## Public Comment No. 126-NFPA 101-2022 [ New Section after 3.3.164.2 ]

## Public Comment No. 5-NFPA 101-2022 [ Section No. 7.1.5.1 ]

**Figure 7.3.1.2(a) Mall Structure Occupant Load Factors (U.S. Customary Units).**

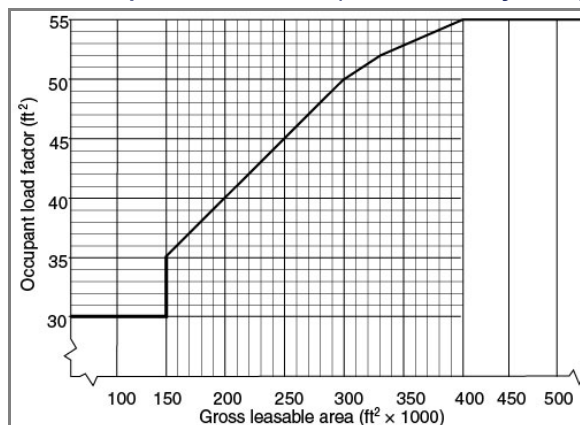
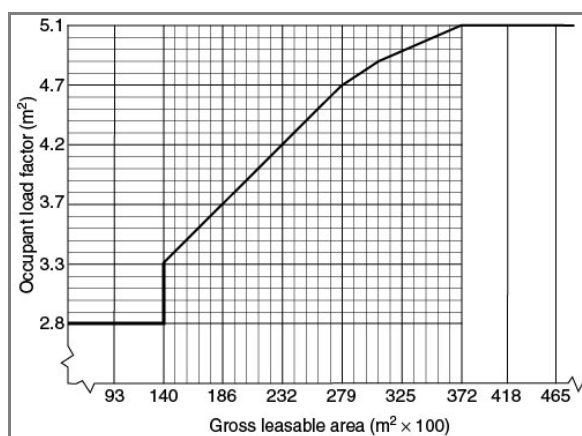
## Statement of Problem and Substantiation for Public Comment

I submitted the same proposal during the First Draft and it was ignored by the NFPA because it was determined to be in the scope of the Assembly Occupancy Committee and it was supposed to be acted on by that committee, but it was not. It is interesting that this same proposal was deemed to be within the scope of the Means of Egress Committee last cycle when it was rejected. Since this has been deemed to be in the scope of this committee at least once in the last few years, this comment is being submitted so that it can't be ignored again if the decision is made that this is in the scope of the Means of Egress Committee.

The Means of Egress committee stated in the previous cycle that their reason for their rejection was, "No data has been provided to substantiate the proposed revision." The Committee Statement is incorrect. The statement that I submitted in support of the proposed change was to account for people in wheelchairs and people who stand up in front of the room that do not have a seat. The egress system needs to account for these people as well as the people in fixed seats. The occupant load needs to include these people so that the egress capacity is actually adequate to handle them.

Asking specifically about the 10% number would have been appropriate. The committee never actually questioned this number, but I can share how it was obtained. The ADA Standards for Accessible Design require a certain number of spaces to be added to fixed seat assembly spaces based on the number of fixed seats. The requirements vary between 1% and 8% for spaces with more than 50 seats (meeting the definition of Assembly). Since the justification for this proposed change is more than just ADA acceptance (such as a professor standing up in front of a class), the 8% number was rounded up to 10% so that there would be one simple rule that would help everyone comply with the ADA and account for everyone who was reasonably going to be in the room.

Alternatively, the committee could refer to the ADA Standards For Accessible Design to figure out how many additional people they should add to the occupant load, but that would be more cumbersome for the user. The 10% number is reasonable, easy to calculate, and provides a number that helps everyone meet the ADA Standards for Accessible Design regardless of the number of seats.
